## COUNCIL WORKSHOP ITEM

**ITEM:** PLAN COMMISSION FILE NO. PC-03-04; Rosol Green Acres Final Plat of Subdivision; Request for Annexation, Rezoning, and Final Plat Approval with Exceptions.  
**DATE:** May 5, 2004  
**PREPARED BY:** Joseph Skach, AIA, AICP, NCARB  
Director, Planning and Community Development  
**PURPOSE:** Consideration of the Plan Commission's recommendation to approve the subject petition

**TO:** Joseph P. Skach, AIA, AICP, Director of Planning & Community Development  
**FROM:** David H. Barber, P.E., Director of Public Works *DHB*  
**BY:** Michael D. Millette, P.E., Asst. Director of Public Works – Engineering  
 Jonathan C. Hall, P.E., Development Engineering Manager II *JCH*  
**DATE:** May 5, 2004  
**RE:** Planning / Zoning Petition for Annexation, Rezoning and Final Plat  
 Green Acres Subdivision – Rosol Construction  
 Public Works Department **4th Review**

**UTILITY PLAN**

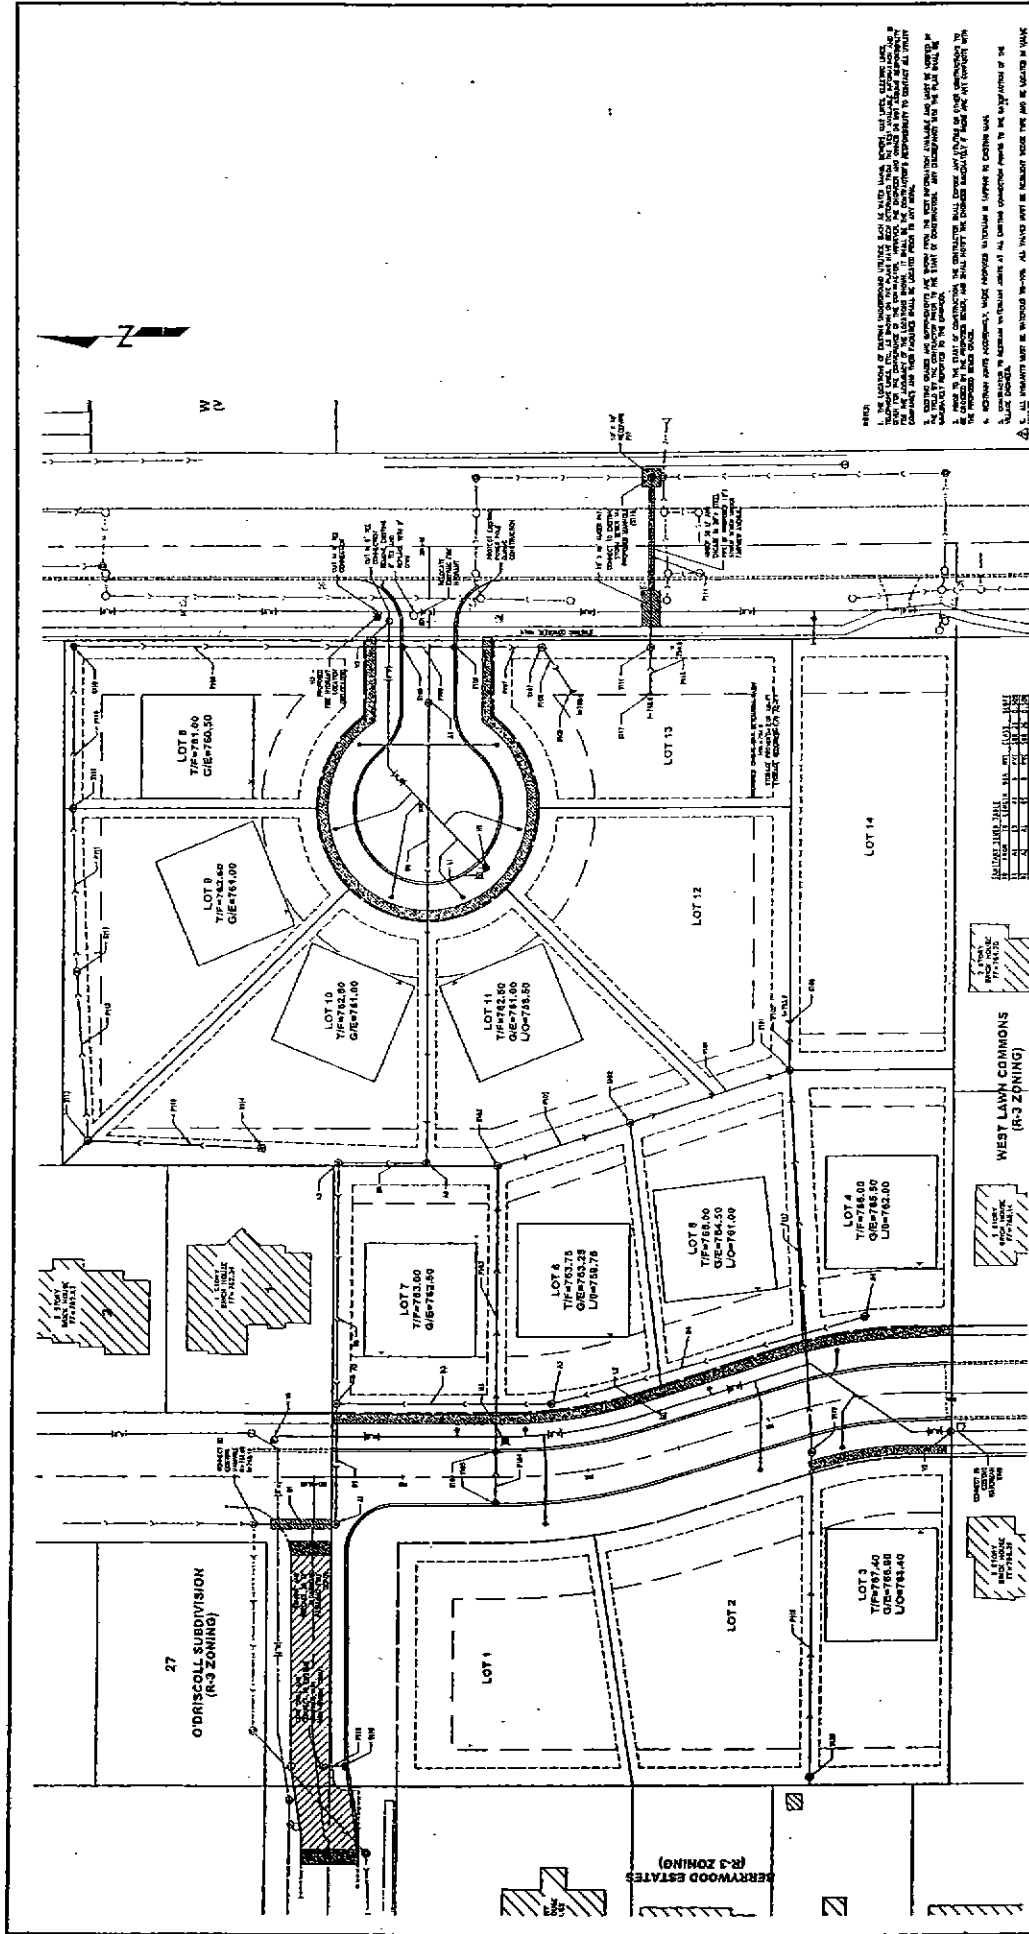
**Accepted**
8. All hydrants must be Waterous WB-100.  
**Accepted**
9. Need to show water service line and B-Boxes on utility drawings.  
**Accepted**
10. Need to show casing and locations of Water & Sewer crossings.

**Not Accepted - Add call-out circles for vertical separation between water services and sanitary / storm services and mains. Add call-out circles for vertical separation between sanitary services and water mains.**

EROSION CONTROL PLAN

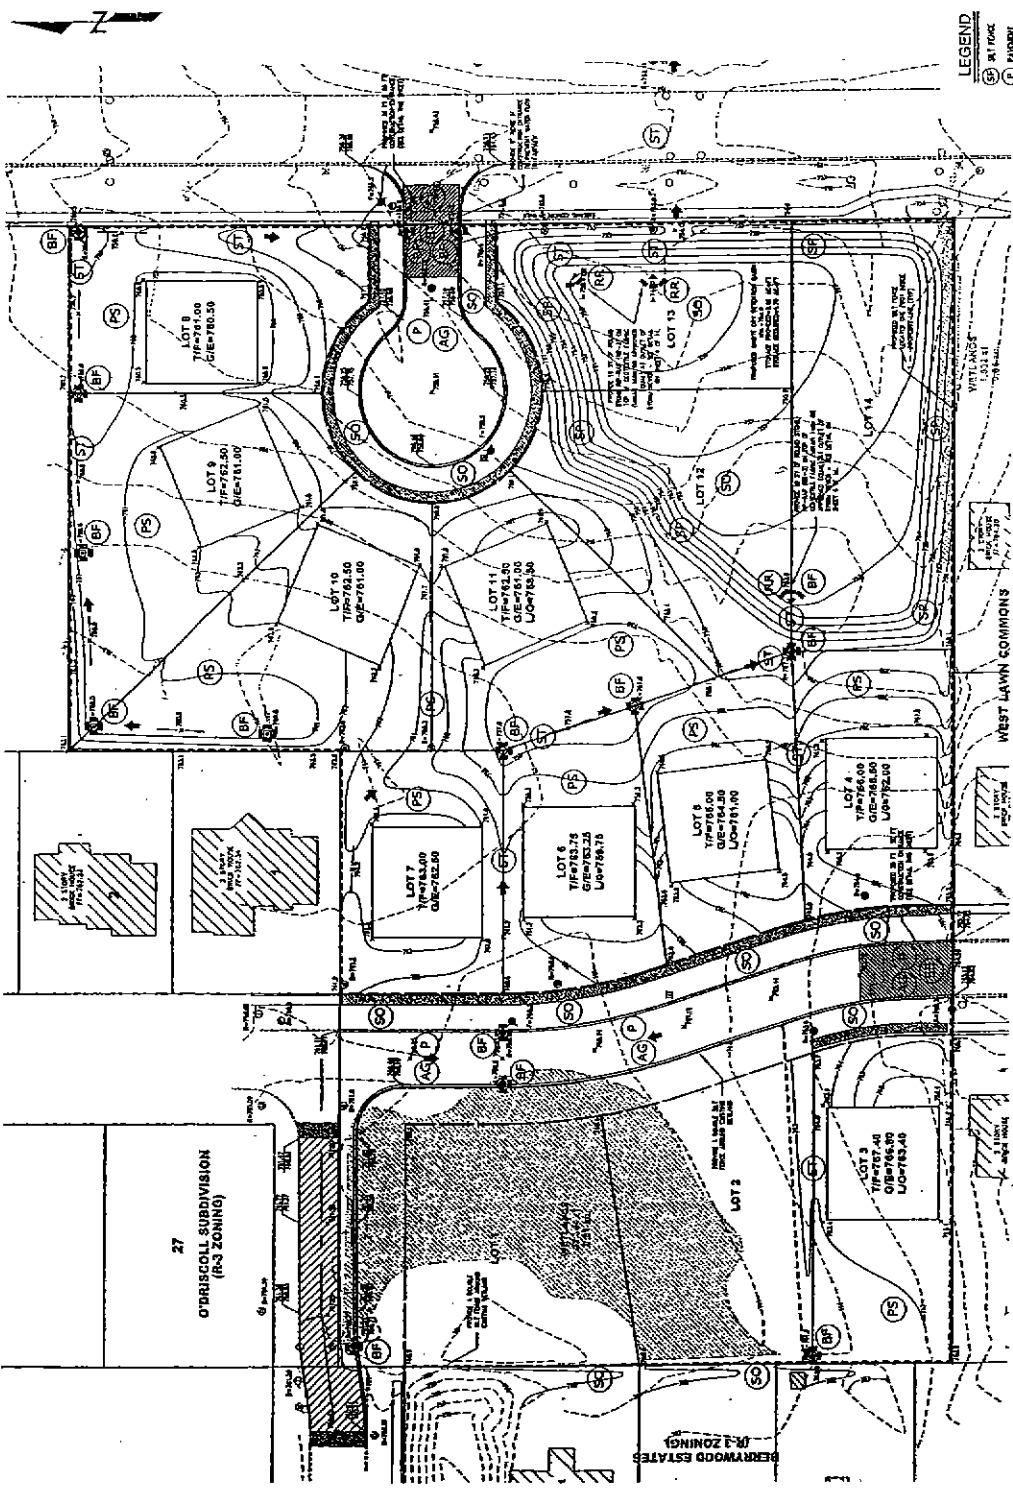
18. Each structure should have a minimum 5 foot "buffer" around its perimeter where the slope is clearly away from the structure.  
**Accepted**
19. On the future erosion control plan, provide for 6-inch high ridges at silt fence openings.

21. Provide a temporary stabilized construction entrance, with a recommended width of 30 feet.  
**Accepted**
22. On the Plat of Subdivision, delineate easements over all storm sewers, overland flow routes, and detention areas. Provide easement language, including provisions for maintenance.
